Subject: [External_Sender] Docket No. 72-1050: Joint Comments on Revision 2 of the Environmental Report (ER) for the WCS Consolidated Interim Spent Fuel Storage Facility
Sent Date: 11/19/2018 5:04:39 PM
Received Date: 11/19/2018 5:05:06 PM
From: Margaret Barnes

Re: Docket No. 72-1050; Joint Comments on Revision 2 of the Environmental Report (ER)
for the WCS Consolidated Interim Spent Fuel Storage Facility

Figure 8: Nuclear Sites and Railroad Routes

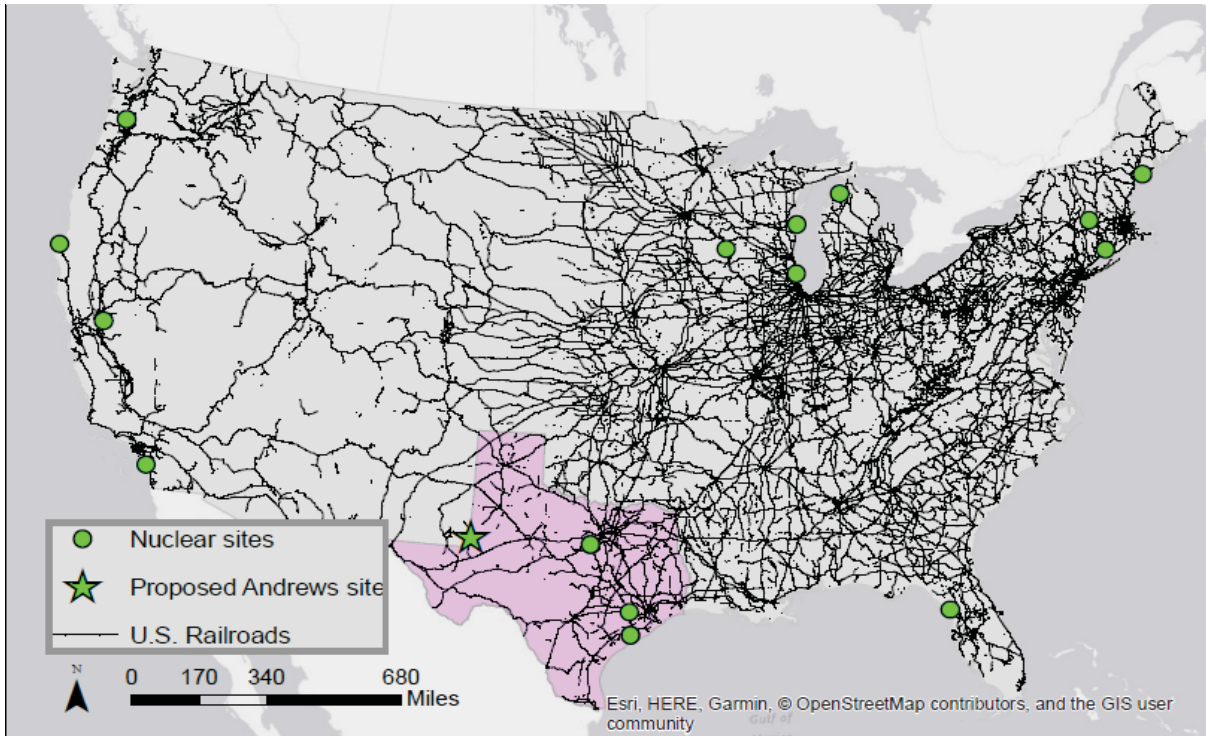
Figure 8, below, shows the 12 shutdown sites named in ISP’s application, three nuclear sites located in Texas (but not named in the application), and where these sites are located along U.S. railroads. While ISP included a “Rail Lines Map” in its application, ER, figure 2.2-4, page 2-71 (Figure 9, below), that map leaves off many hundreds of miles of possible rail transportation routes.

Figure 9: ISP’s “Rail Lines Map”

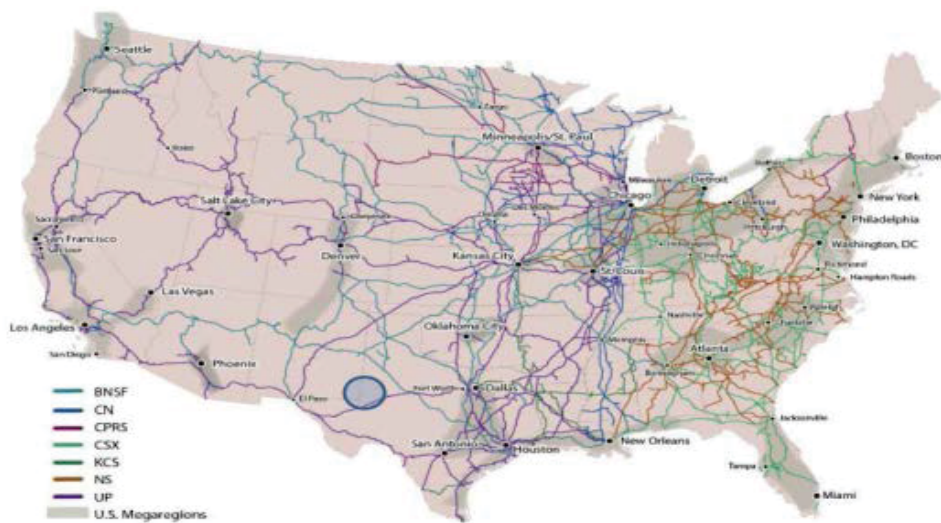
of the routes in their application: one from the Maine Yankee facility to WCS, one from the San Onofre facility in a southern California facility to WCS, and one from WCS to Yucca Mountain. ER, Figure 2.6-1, Page 2-78 (reproduced below as Figure 7). Again, the routes were chosen with cost in mind and, even then, the routes are merely vague outlines; the map which shows these routes does not have cities labeled.
